Attachment A

1. Replace page 6.1-1 with the enclosed replacement 6.1-1.
2. Replace pages 6.2-1 through 6.2-3 with the enclosed replacement pages 6.2-1 through 6.2-6.
3. Replace page 6.5-2 with the enclosed replacement page 6.5-2.

R. E. GINNA STATION

ORGANIZATION

Figure 6.2-1

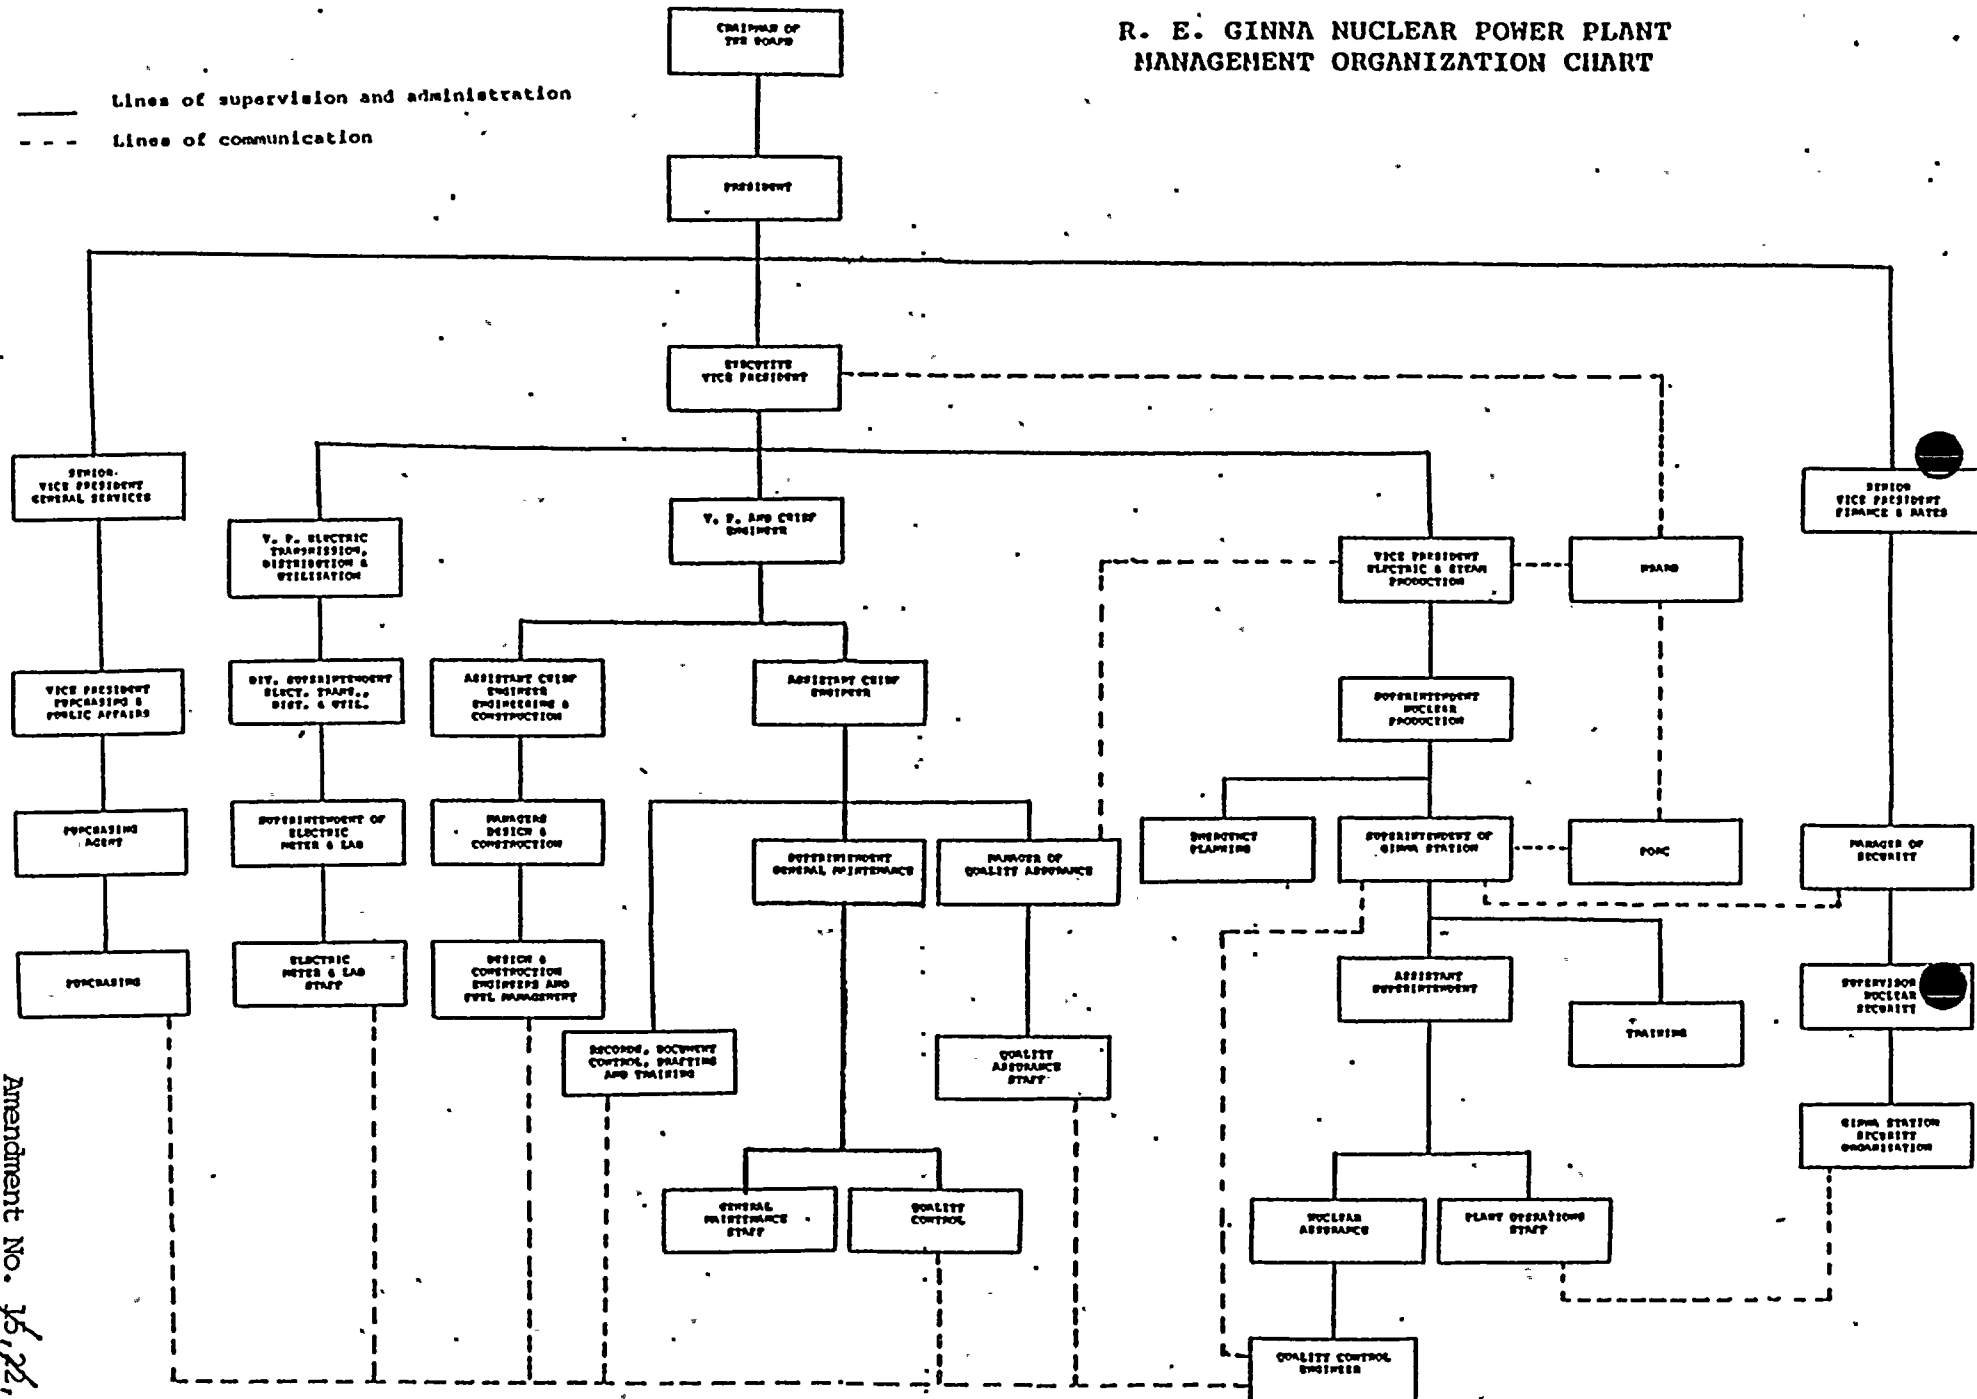
- 6.2.1 The offsite organization for facility management and technical support shall be as shown on Figure 6.2-1.

Figure 6.2-2

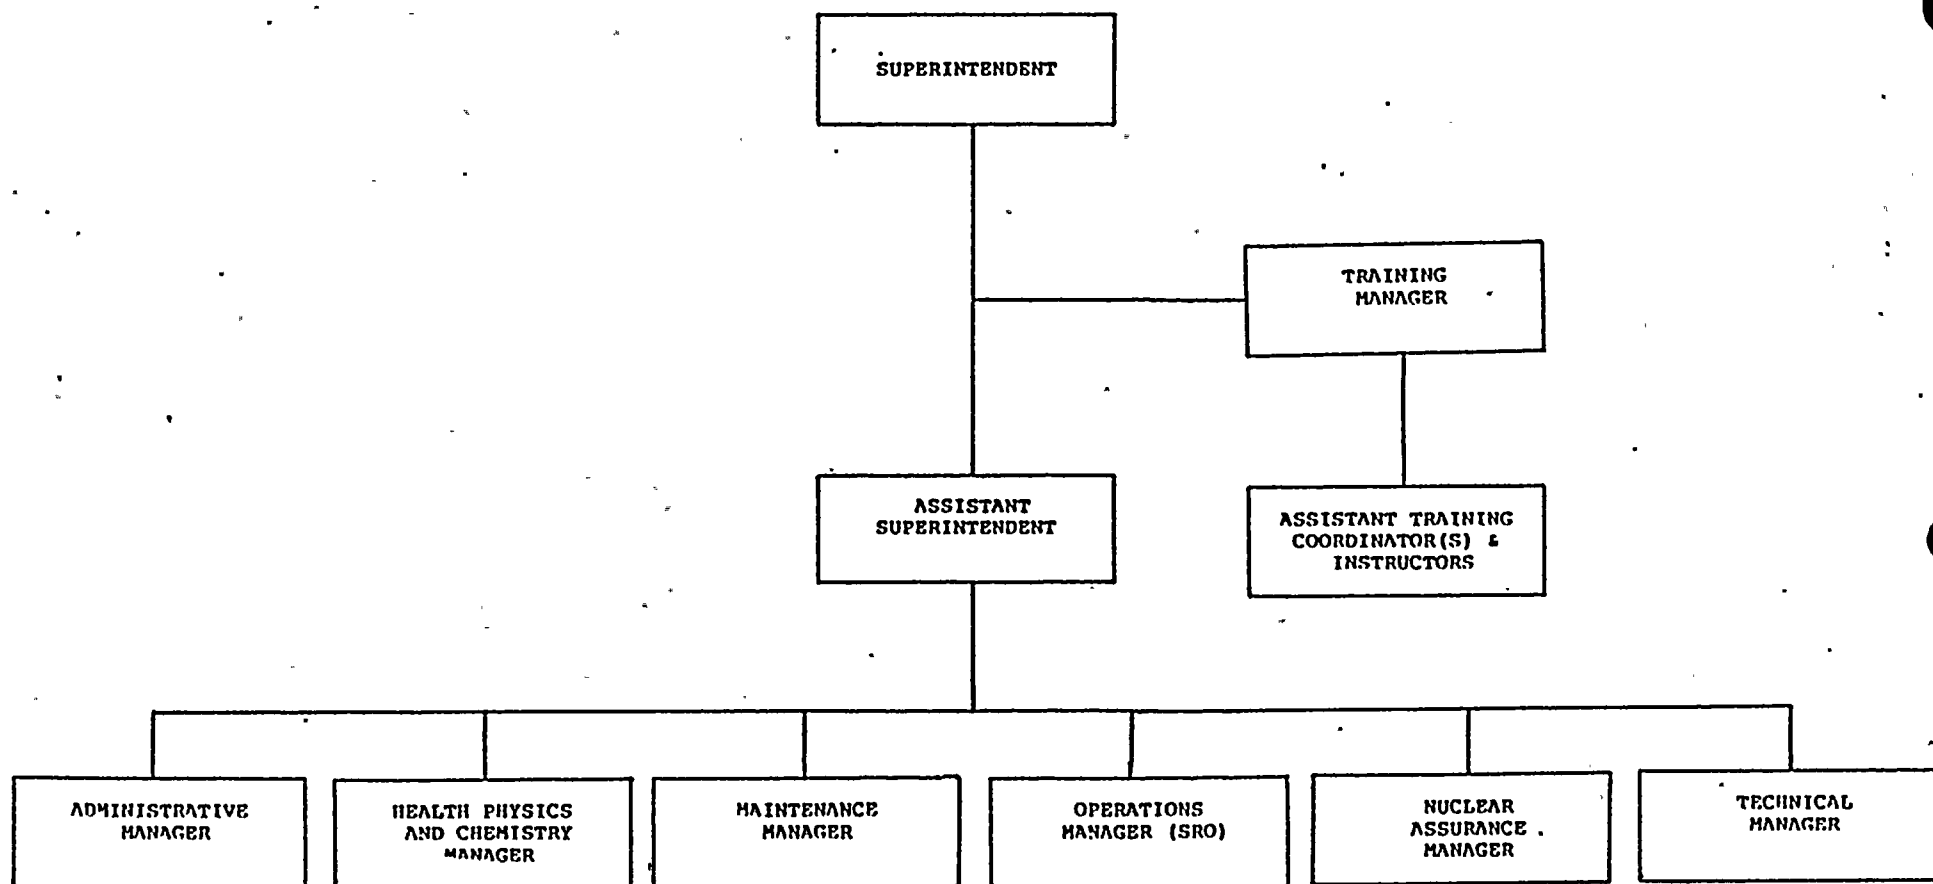
- 6.2.2 The Facility organization shall be as shown on Figures 6.2-2, 6.2-3, 6.2-4, & 6.2-5 and:
- a. Each on duty shift shall be composed of at least the minimum shift crew composition shown in Figures 6.2-3, 6.2-4, and 6.2-5.
 - b. At least one licensed Operator shall be in the control room when fuel is in the reactor.

The proposed Technical Specification change identified in Attachment A, reorganizes the staff into major functional sections. These functional sections include an Administrative section, a Health Physics & Chemistry section, a Maintenance section, an Operations section, a Nuclear Assurance section, and a Technical section. The two new sections, Administrative and Nuclear Assurance are discussed below.

Figure 6.2-3

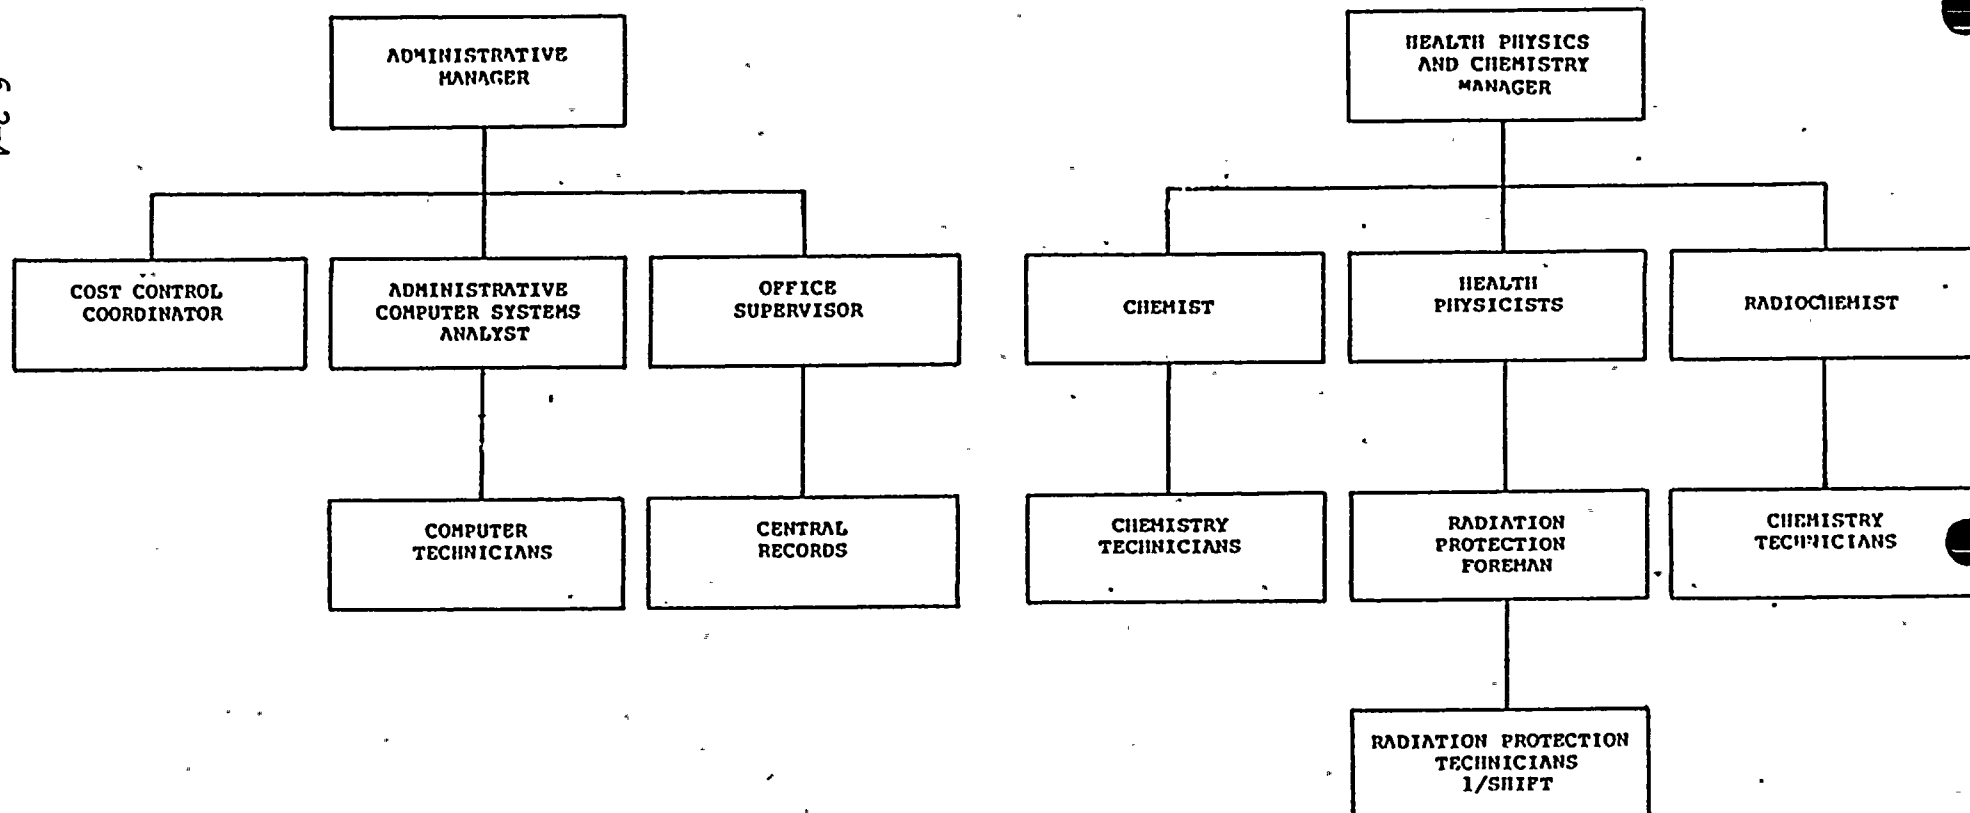
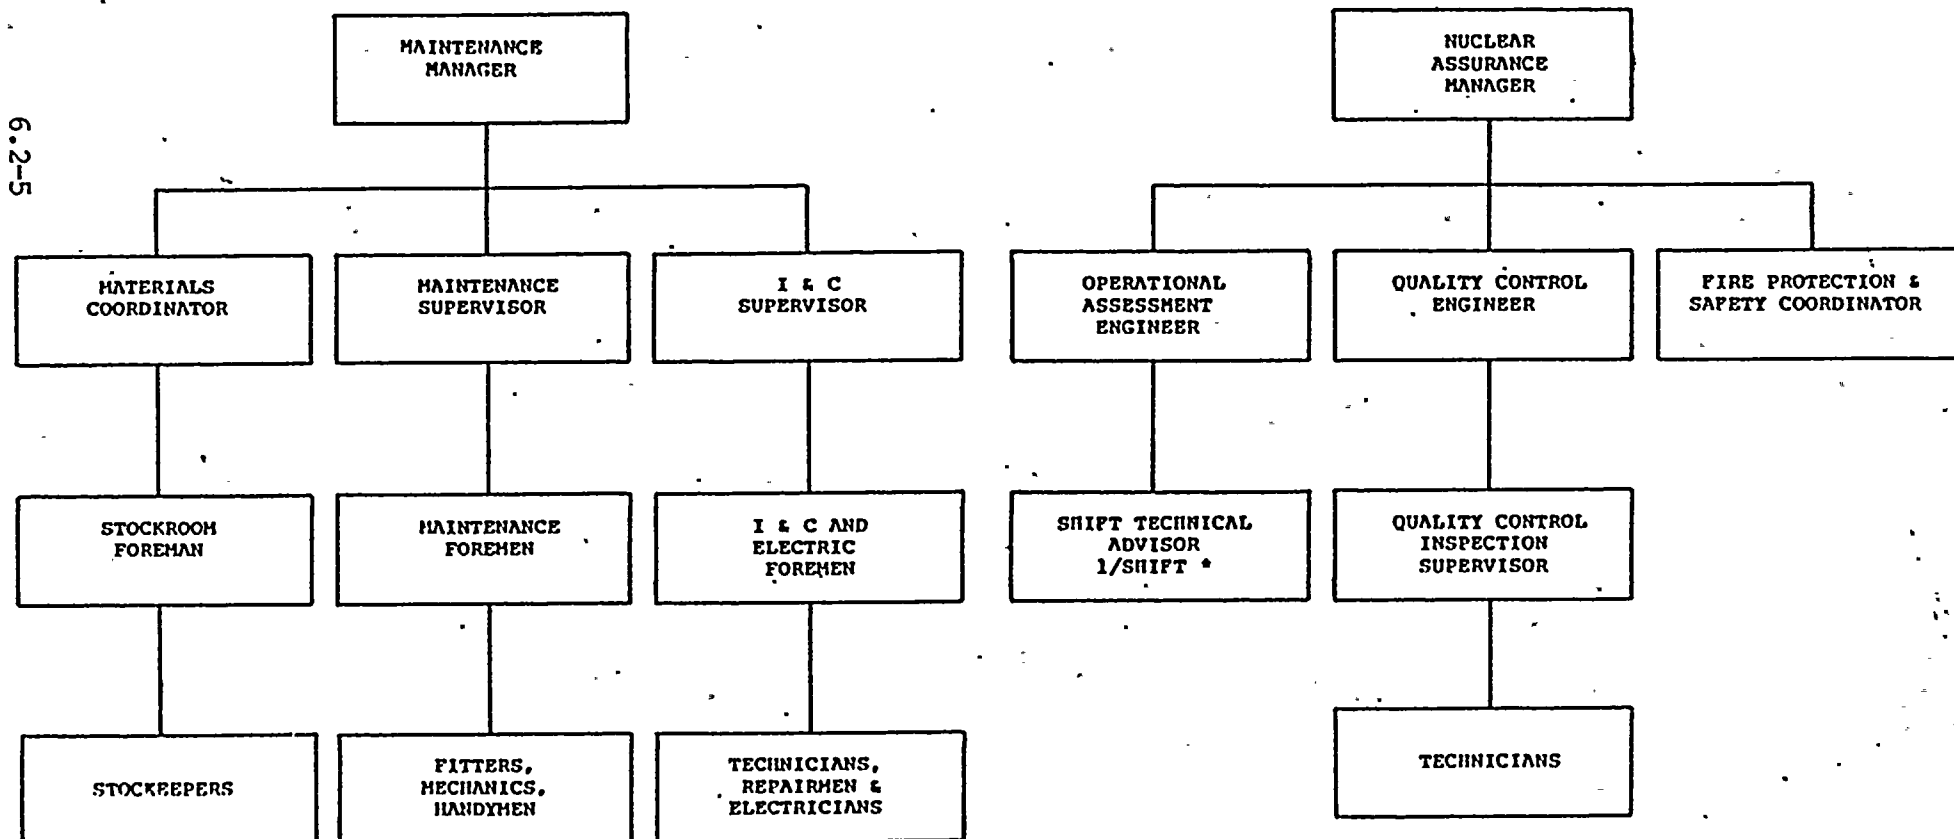
Reporting to the Administrative Manager will be the functions of Cost Control Coordinator, Administrative Computer Systems Analyst, and the function of the Office Supervisor. This change will allow for these support functions to form a cohesive support

Other changes include the positions of Radiation Protection Foreman and Radiochemist in the Health Physics & Chemistry section, the change in title of the Nuclear Engineer to Reactor Engineer, the addition of the Technical Projects Supervisor and Technical Computer Systems Analyst in the Technical section, and the renaming of the Supervisor of Health Physics and Chemistry to the Health Physics and Chemistry Manager, the Maintenance Engineer to the Maintenance Manager, the Operations Engineer to Operations Manager, the Technical Engineer to Technical Manager, and the Training Coordinator to Training Manager.
